## **OPDC POST SUBMISSION MODIFIED DRAFT LOCAL PLAN**

### **Agenda 2 for Modifications Hearings:**

#### **Conformity with London Plan policy D9 on Tall Buildings**

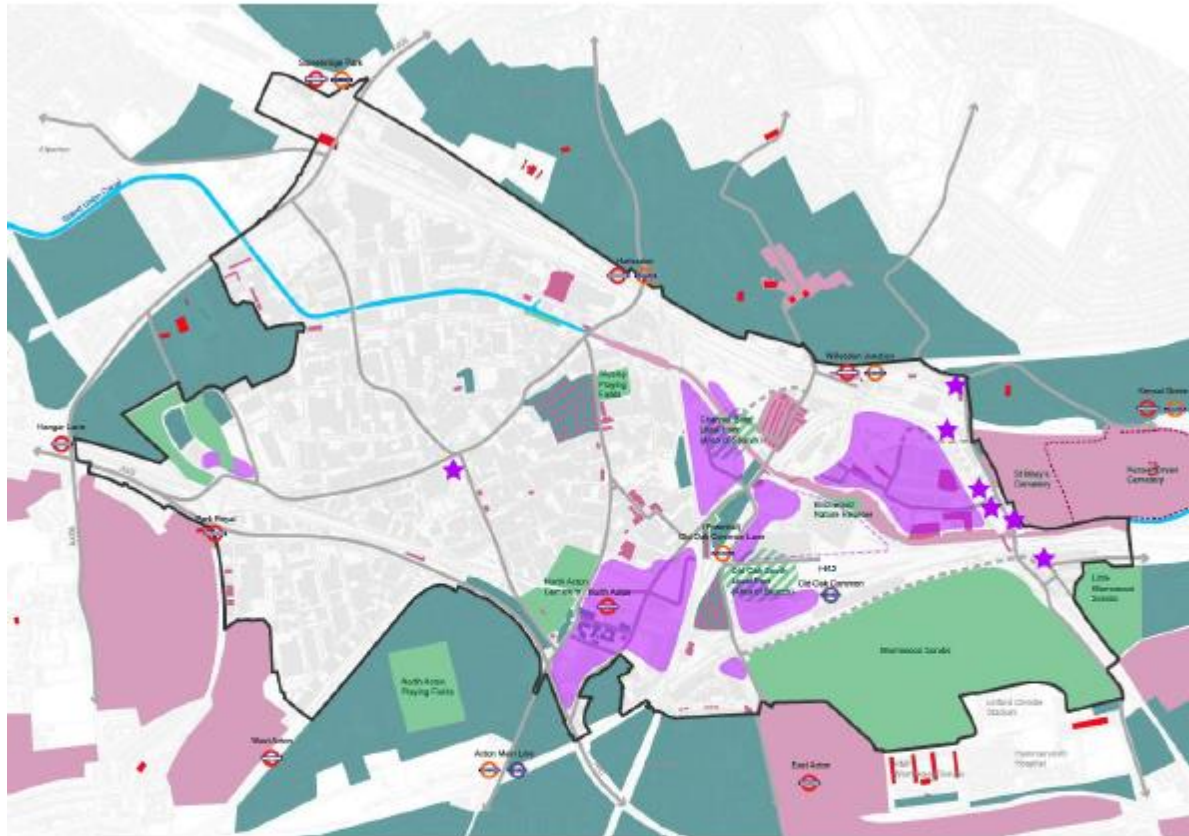
OPDC would seem to be assuming that the modified figure 3.15 is sufficient to achieve general conformity with the ‘*suitable location*’ requirement in London Plan Policy D9.

This map of the OPDC area identifies (with asterisks) a series of specific locations for tall buildings along Scrubs Lane. All but one of these asterisks show sites on which OPDC has since 2015 granted planning consent to such buildings (in the 20- 30 storey range). As we have argued in the past, this has been an exercise of retro-fitting a Local Plan around sites acquired by speculative developers in

advance of plan preparation. Nevertheless we accept that these locations are identified with sufficient specificity to meet London Plan D9.

In relation to other areas where tall and very tall buildings are planned by OPDC, this map at 3.15 defines sizable areas of several hectares in each case. The purple areas of North Acton/Acton Wells is an area of 32.9 hectares<sup>1</sup>. Channel Gate/Atlas Road is approximately 14 hectares.

The term ‘location’ in plain English means ‘a particular place or position’. It does not mean a substantial area of many hectares or the totality of a ‘Place’ as used by OPDC in its Local Plan. The whole intent of the SoS Direction of December 2020 was that the public should be made aware, through Local Plans, of specific locations considered suitable for tall buildings. Part C of London Plan D9 sets out criteria in assessing what makes a location ‘suitable’. For London, where tall buildings have been a growing public concern, local plans are now expected to have been through a full process of consultation leading up to the identification of such locations as being ‘suitable’.

**We do not see SP9 and its associated map as being even close to meeting the requirements of London Plan D9.** As one of the first new Local Plans to be adopted post the Secretary of State’s intervention on the Tall Buildings policy in the London Plan<sup>2</sup>, we see the outcome of this examination to be critical to future interpretations of the ‘general conformity’ requirement on this important planning issue for all Londoners. Nor do we see Places P5 and P7 (as referred to above) being the most significant Places where much clearer policy content is needed than in the present PSMDLP. Renumbering may be needed?
